**HEB AUSTIN NO 33**

*Pamela Abee-Taulli  
Environmental Program  
Coordinator,  
Development Services  
Department*

**SP-2020-0400D**

# VARIANCE REQUESTS

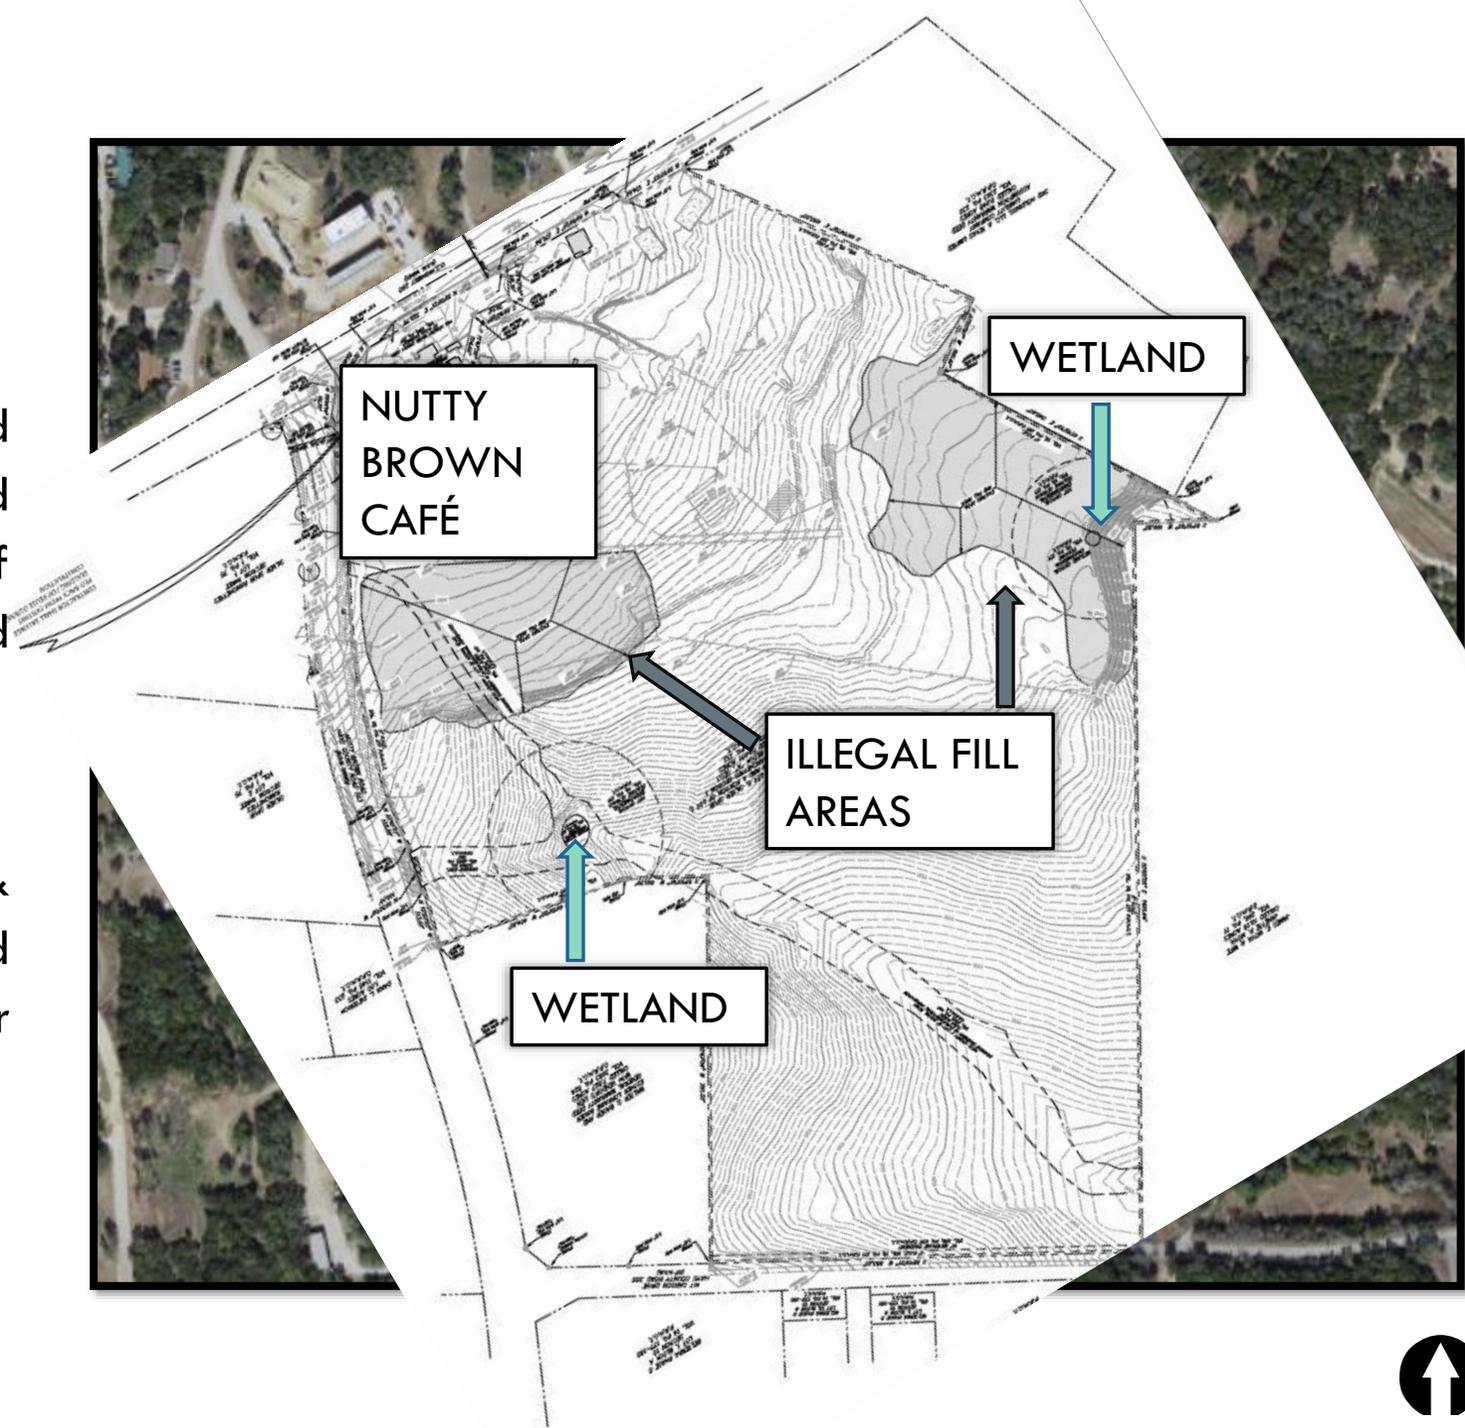
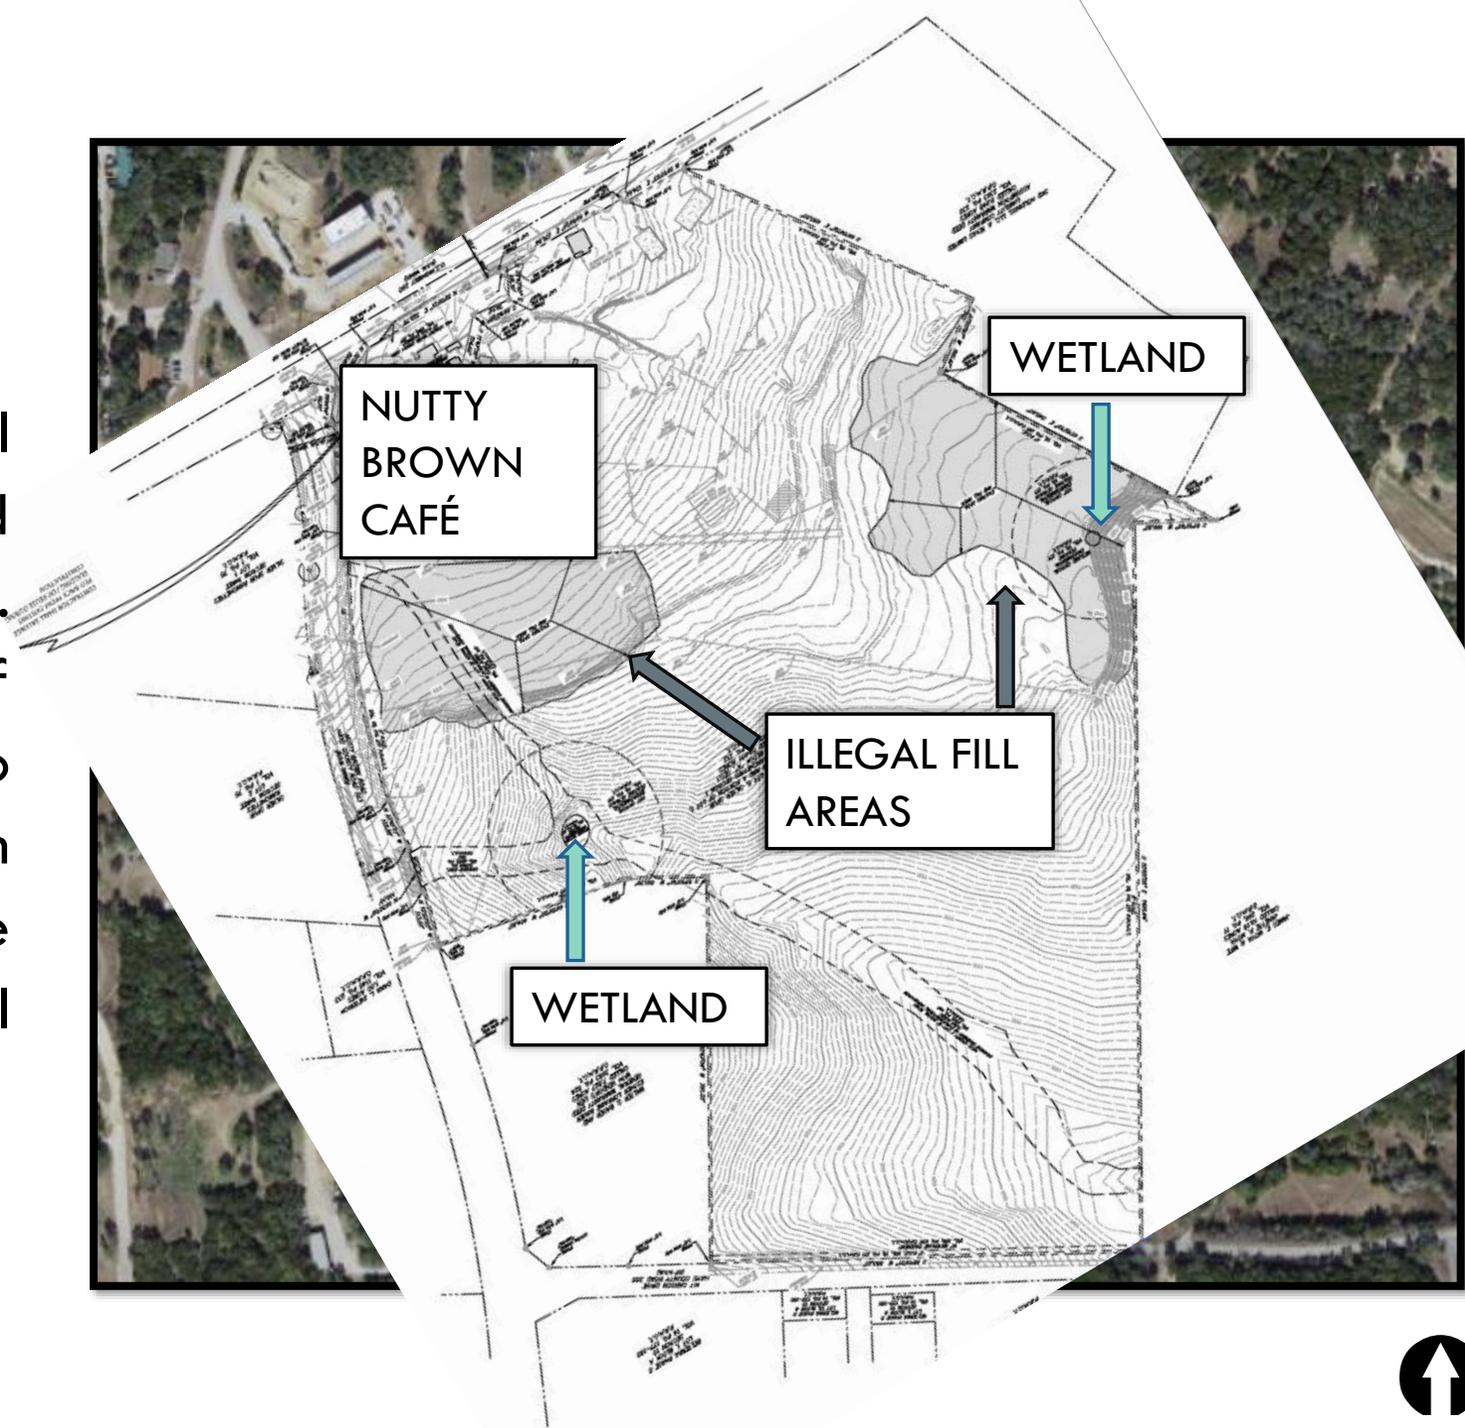
For over a decade, the site has had unpermitted fill material, which changed both the topography and hydrology of the area, cutting off flow to a wetland critical environmental feature.

Additionally, the Nutty Brown Café & Amphitheater had illegally expanded and increased its impervious cover beyond the allowable limit.

As part of this project, HEB will remove the unpermitted development and the illegal fill. Areas outside of the footprint of the HEB project will be returned to original grade and restored with native vegetation. Drainage to the two wetland critical environmental features will be restored.

1. Applicant will restore illegal fill that currently exists on the site to original grade.
2. Applicant will use native plants appropriate for the Hill Country location for revegetation.
3. The applicant will provide mitigation in the form of payment or on-site plantings for removed trees with a diameter of 19 inches or greater at a rate of 100 percent.

# VARIANCE REQUEST 1

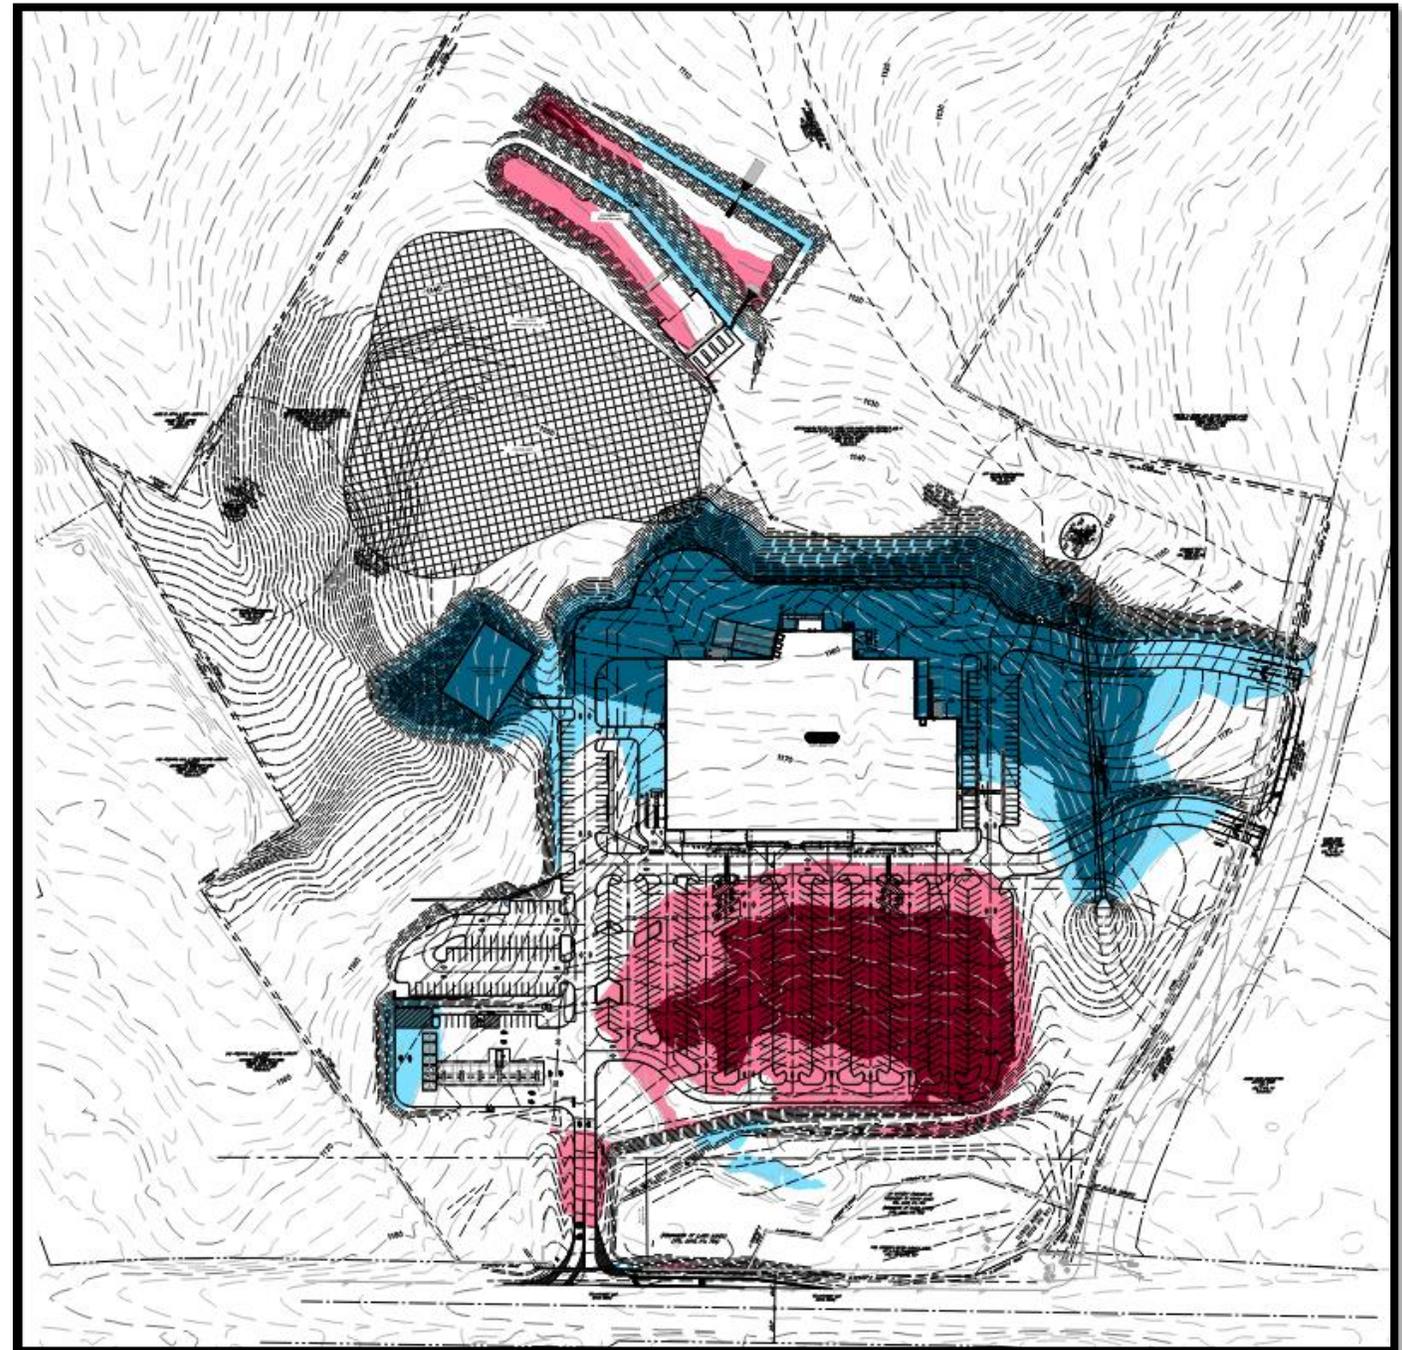
Allow **cut** over 4 feet to 12 feet.

# VARIANCE REQUEST 1 & 2

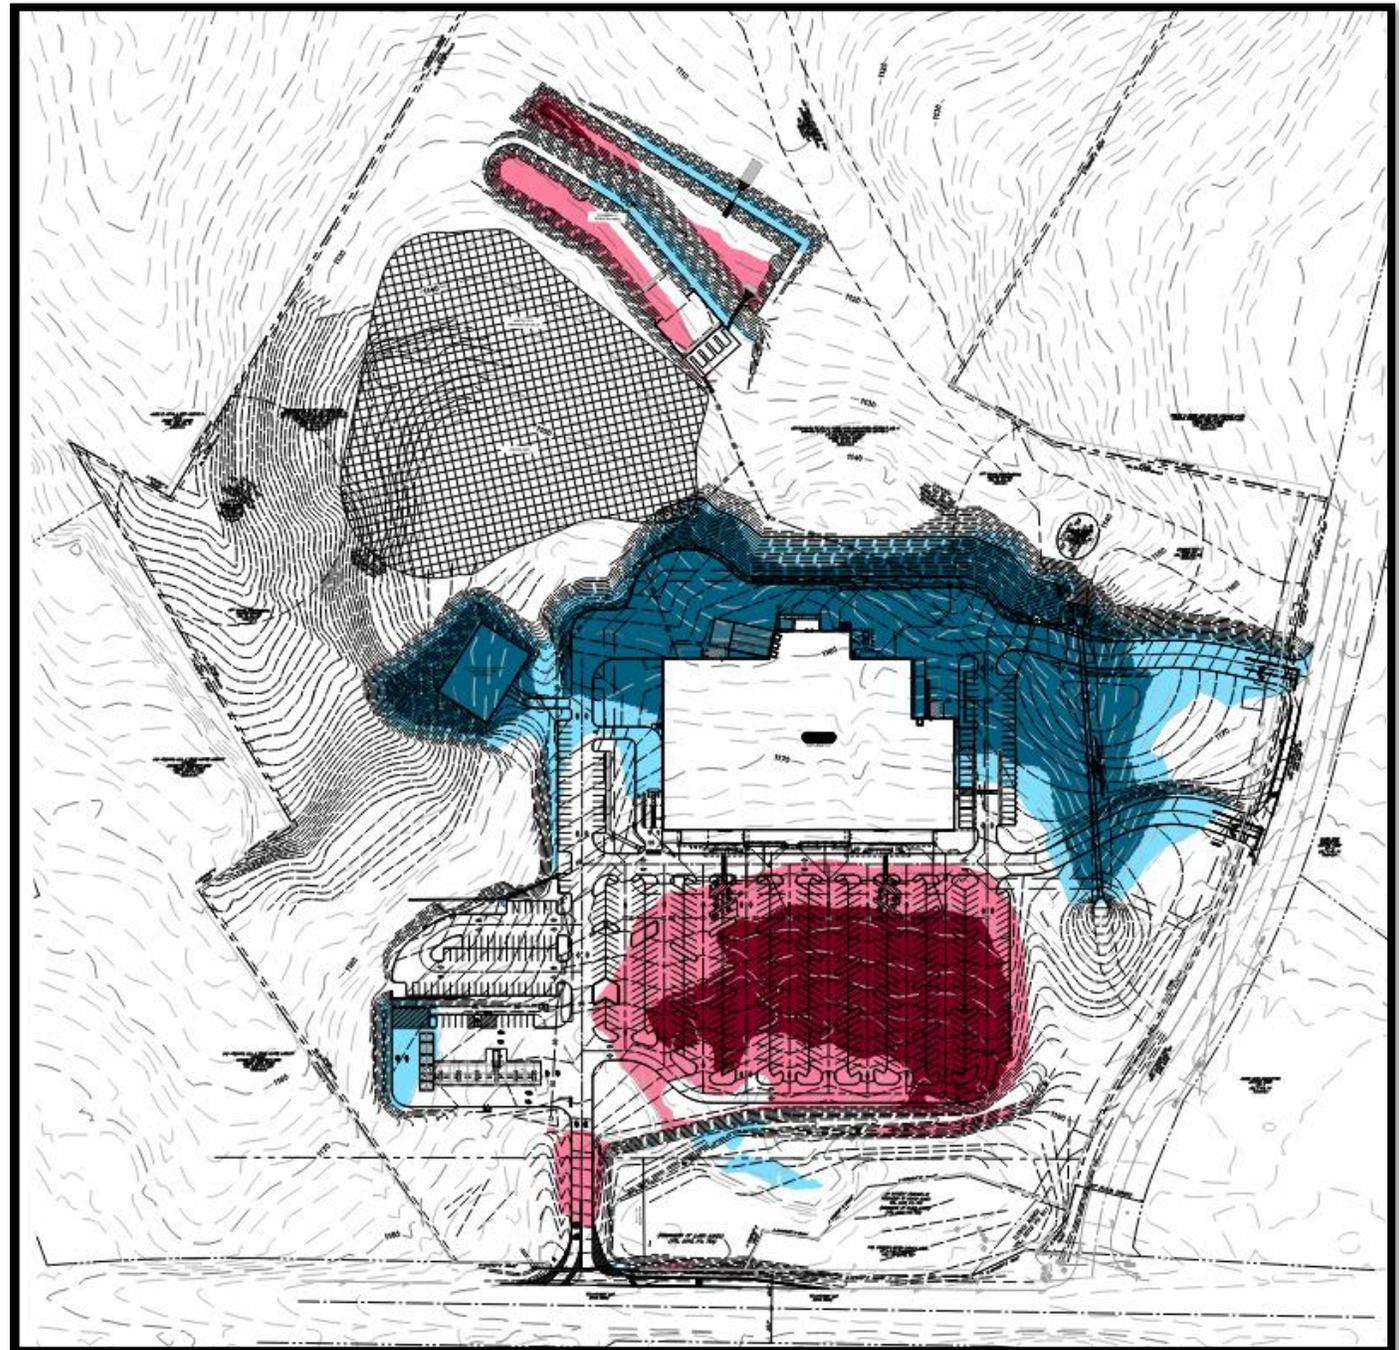
Allow **cut** over 4 feet to 12 feet.

Allow **fill** over 4 feet to 21 feet.

# VARIANCE REQUEST 1 & 2

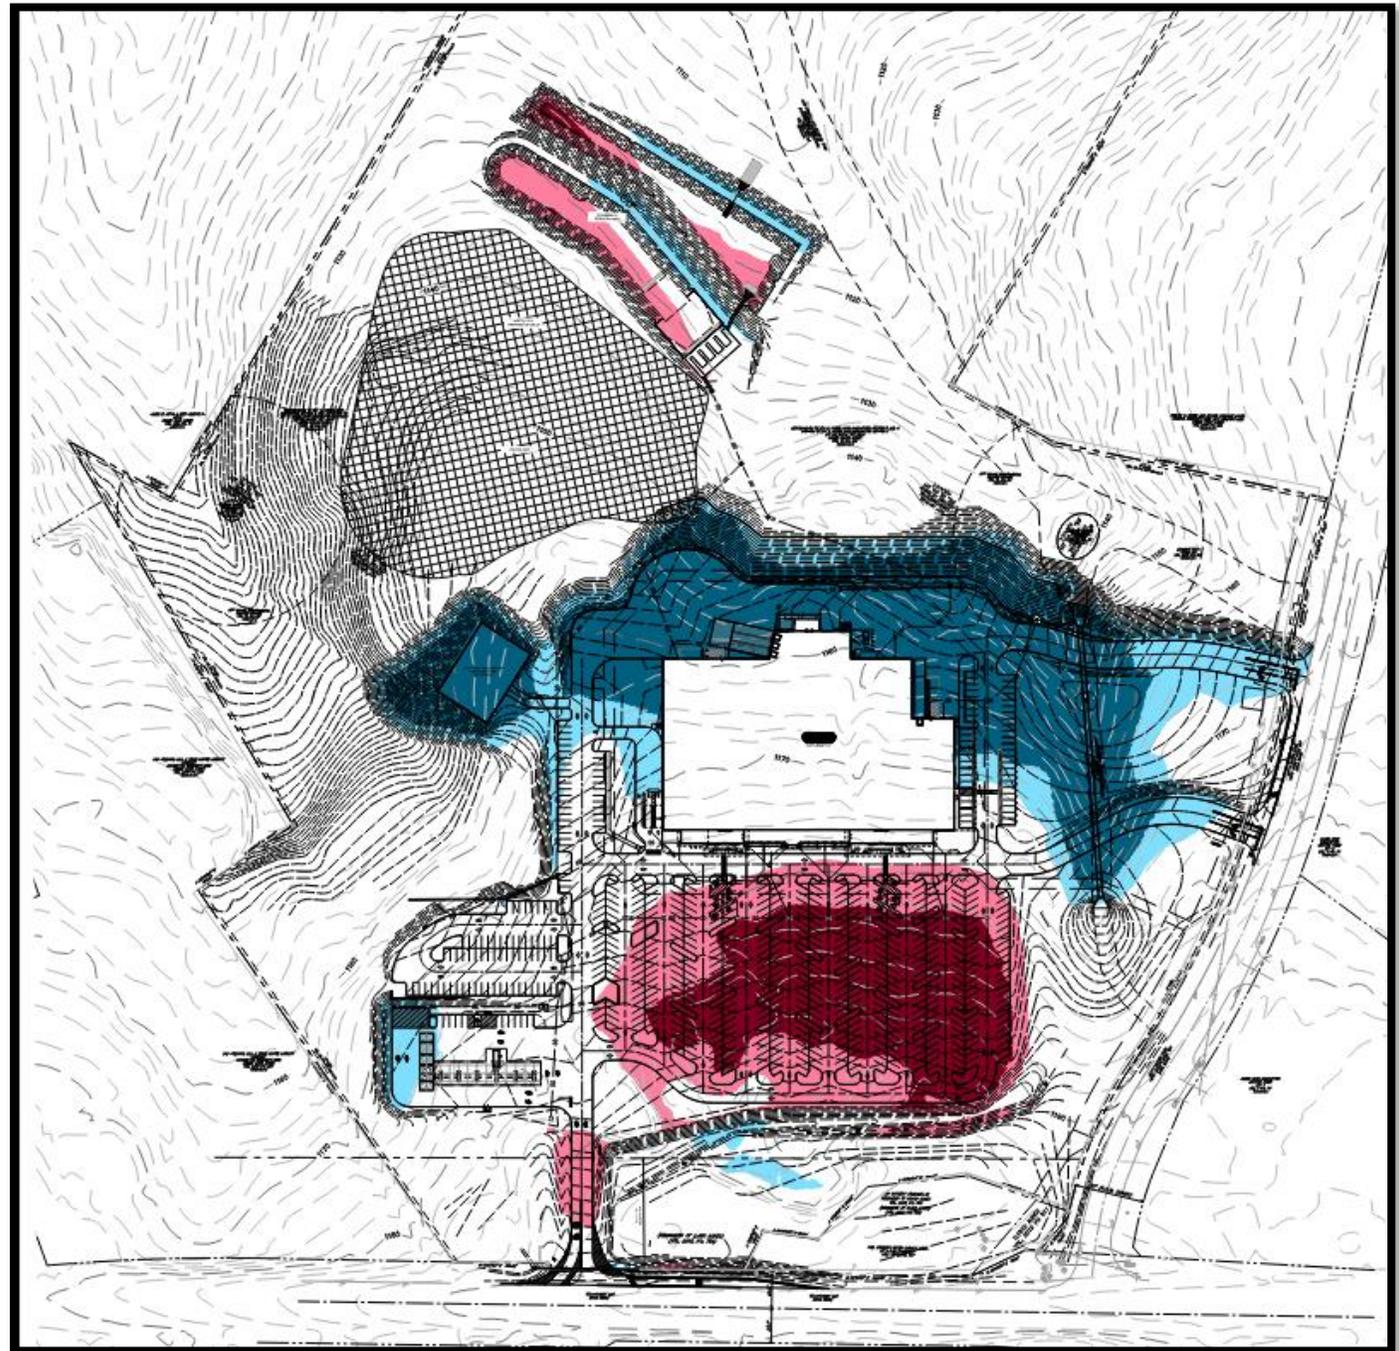
Allow **cut** over 4 feet to 12 feet.

Allow **fill** over 4 feet to 21 feet.

The grading is to level the parking and building.
